**MEETING OF THE
PLANNING AND ZONING BOARD
QUASI-JUDICIAL PUBLIC HEARING**

May 21, 2019

**TOWN OF BAY HARBOR ISLANDS
DRC STAFF
PLAN REVIEW**

**RE: BELIZA 1170 102 STREET
RESPONSE TO COMMENTS BY MICHAEL MILLER PLANNING ASSOCIATES, INC.**

P & Z PROPOSED REVISION EAS-WEST SECTION 2

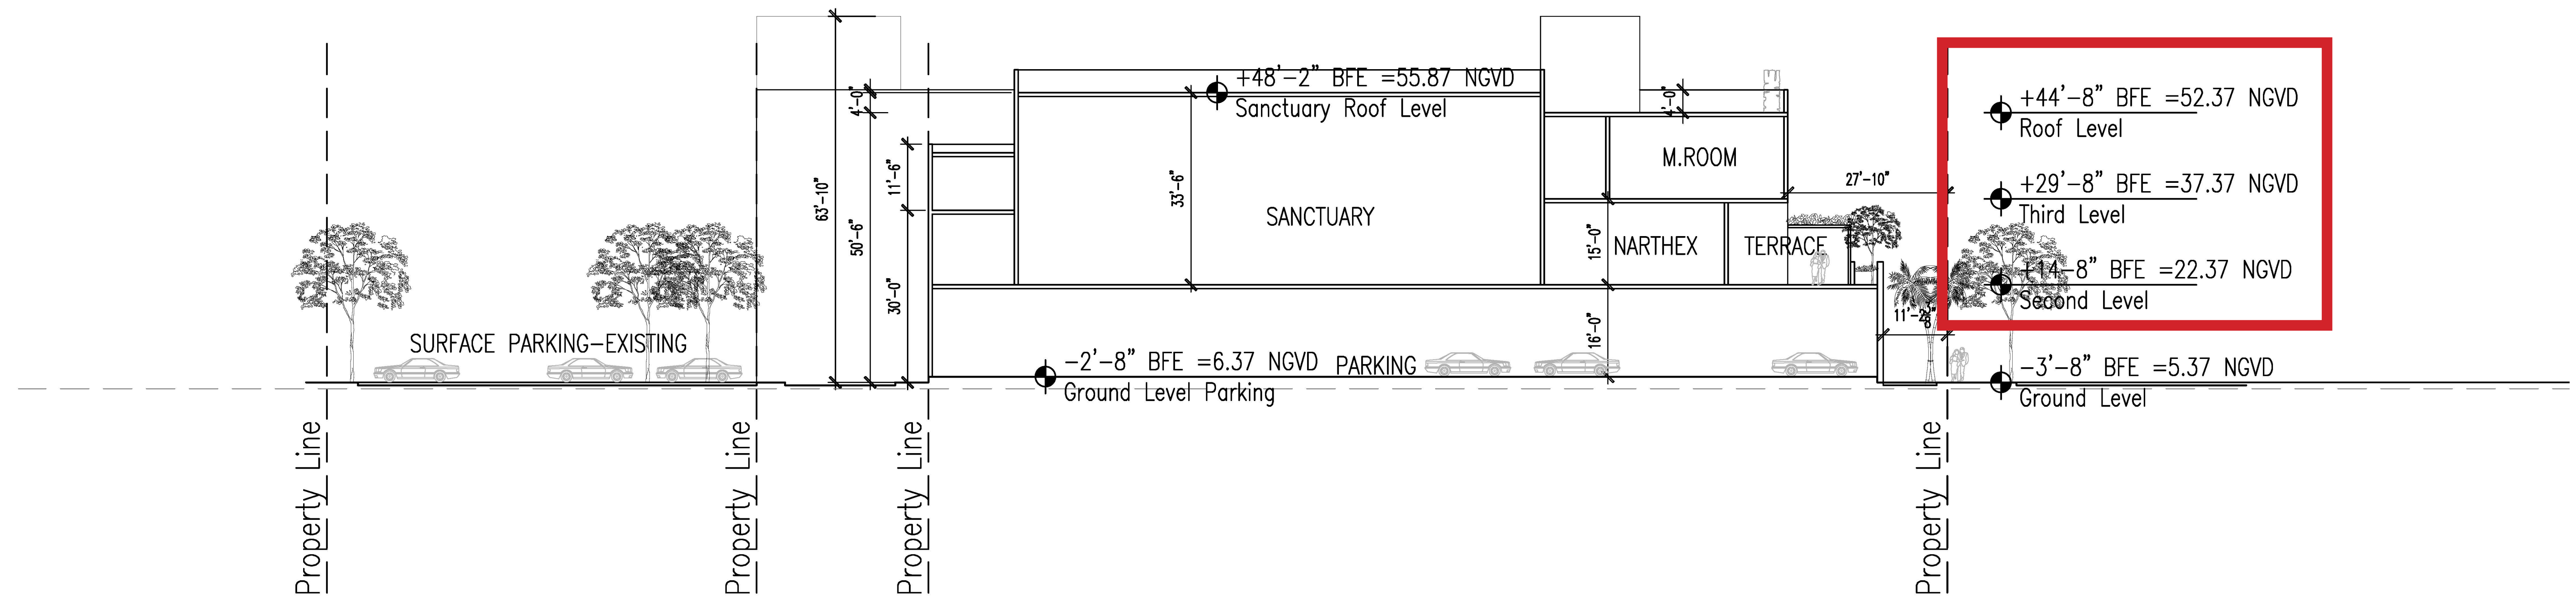
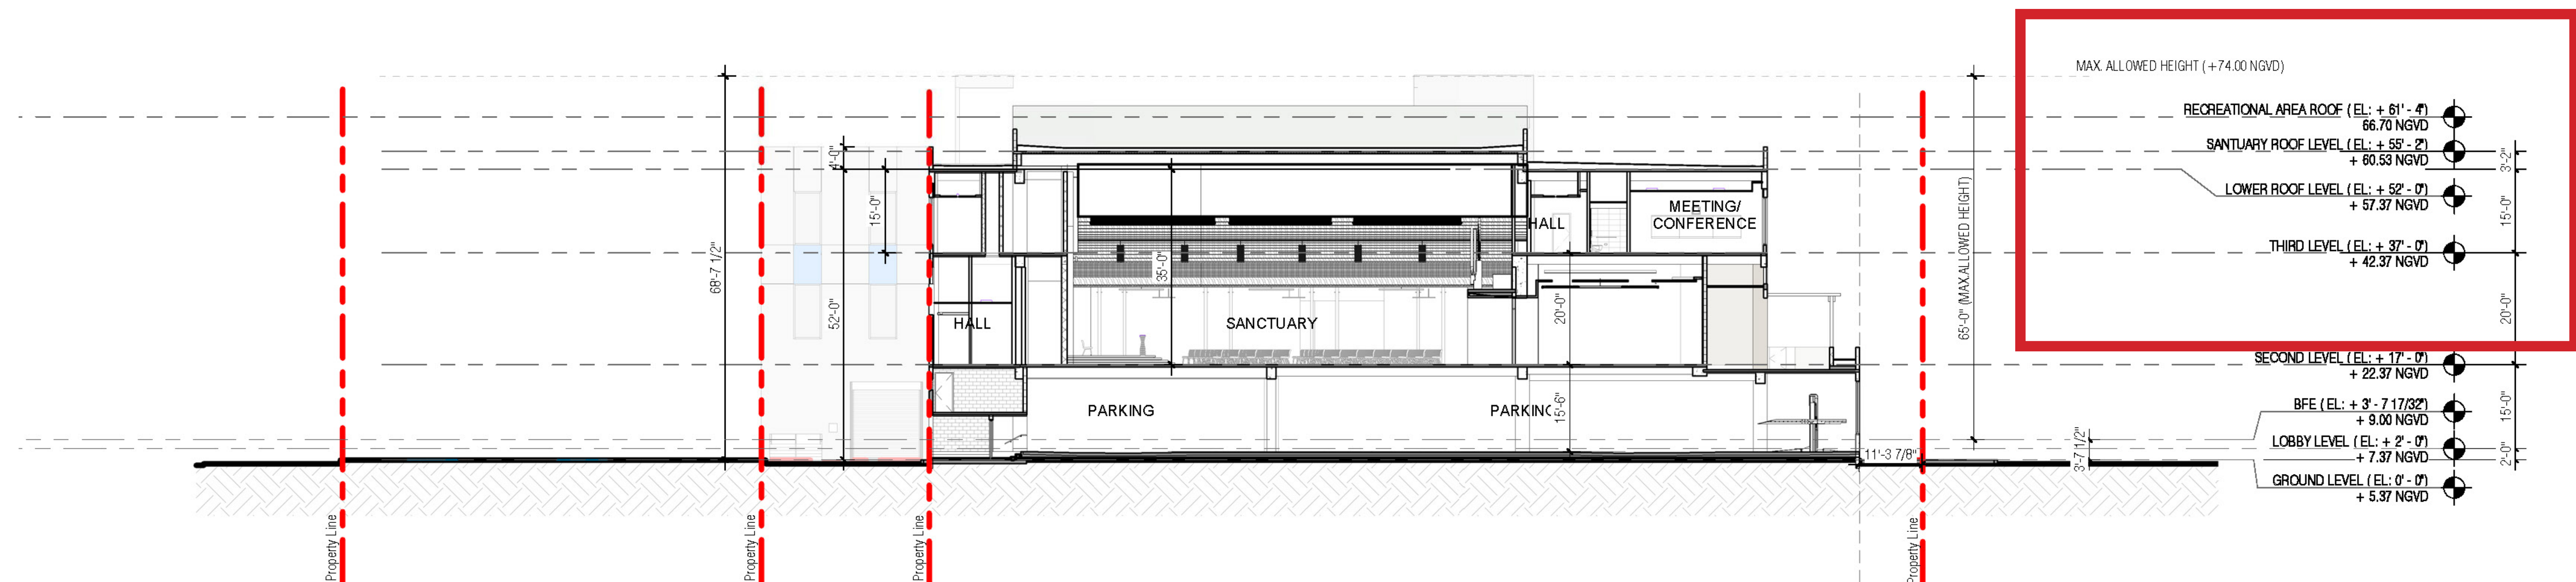
ADDITIONAL HEIGHT ON SECOND FLOOR/ SANCTUARY; LANDSCAPE NOT SHOWN IN PROPOSED SECTIONS

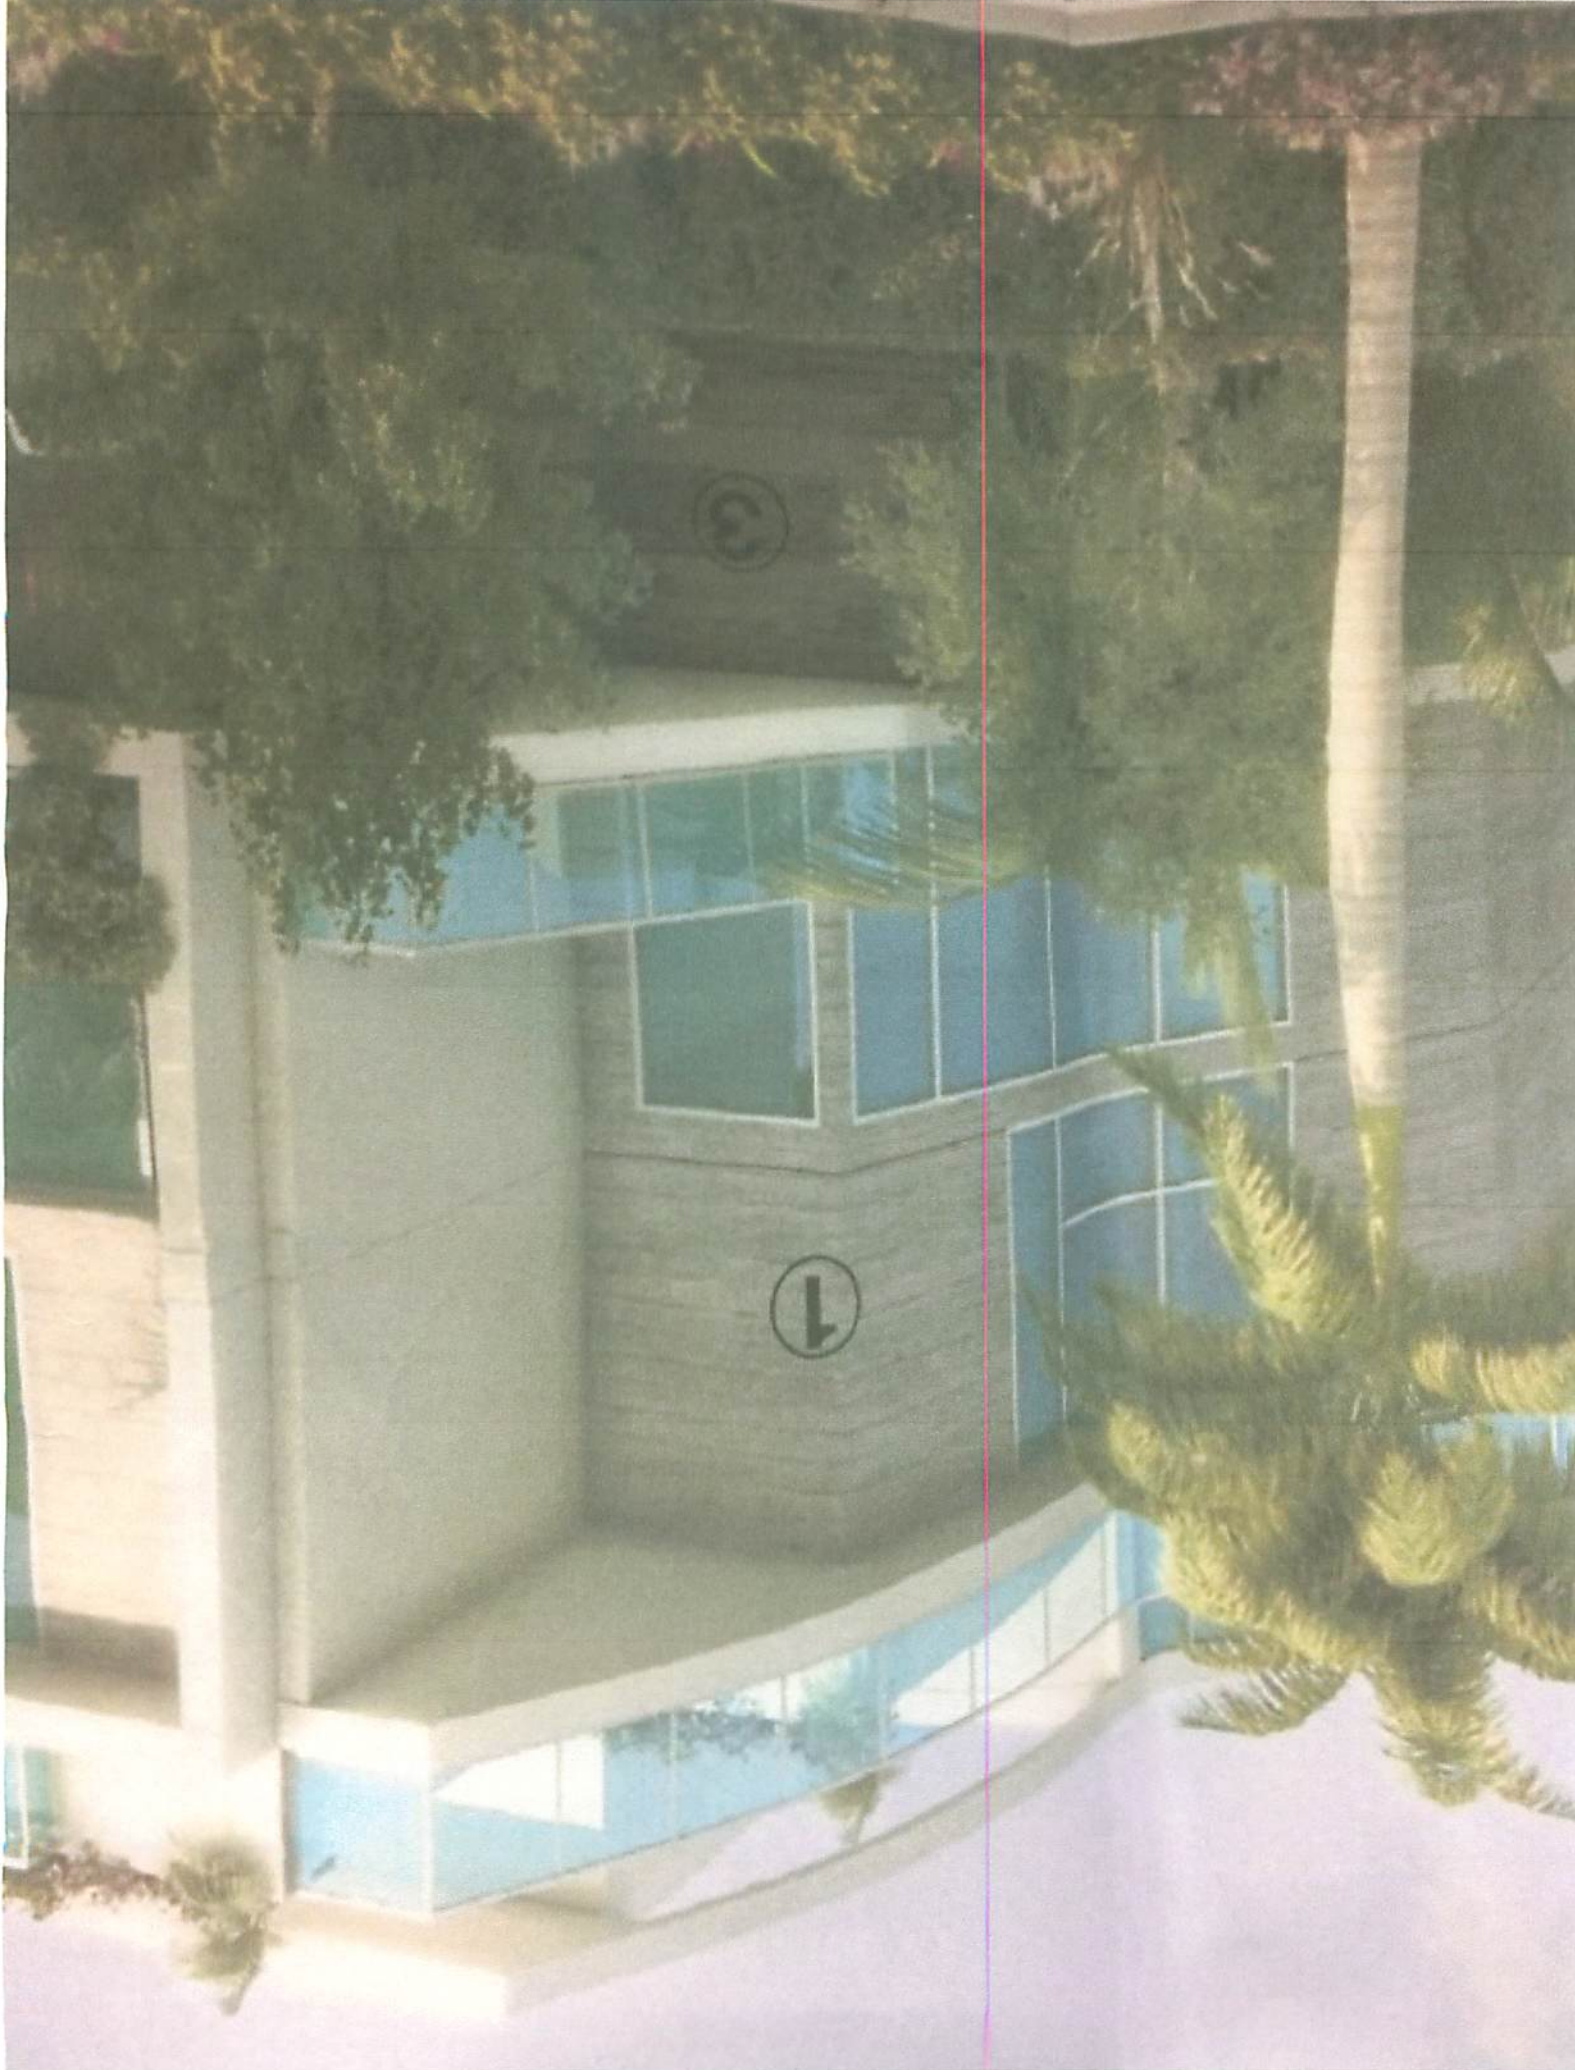
- a) On the west building elevation (south bldg.) large electrical meters / utility service connections were installed for the entire complex. They are facing adjoining residential unit bedrooms - the wood fence / landscaping does not screen properly. These need to be better screened (covered panels / painted / chases over conduit & exposed wires). The location is not consistent with the approved PZB plans. **Meter boxes / conduit to be painted to match main building color. Loose wires to be enclosed. Additional landscaping to be added for screening to adjoining sites.**
- b) An exterior door / stair was added from Unit 6 facing EBHD down to a "garden". These features are not shown on approved PZB plans. **Revision is OK to MMPA but varies from PZB plans.**

- c) Along the west property line next to the north building a CBS wall was constructed. This provides great screening for the adjoining site. For some reason a hole was punched through the wall and a drainpipe was installed that would appear to drain into the neighboring site. Remove the PVC pipe and patch the hole. Drainage must be kept solely on the new townhouse site. **Corrected.**

The electrical equipment boxes will be painted in a color to match existing wall. Loose tv/cables are temporary and are going to be boxed or pulled into the units through the conduits below. Refer to sheet A-6 showing revision number 9 cloud for the electric meters.
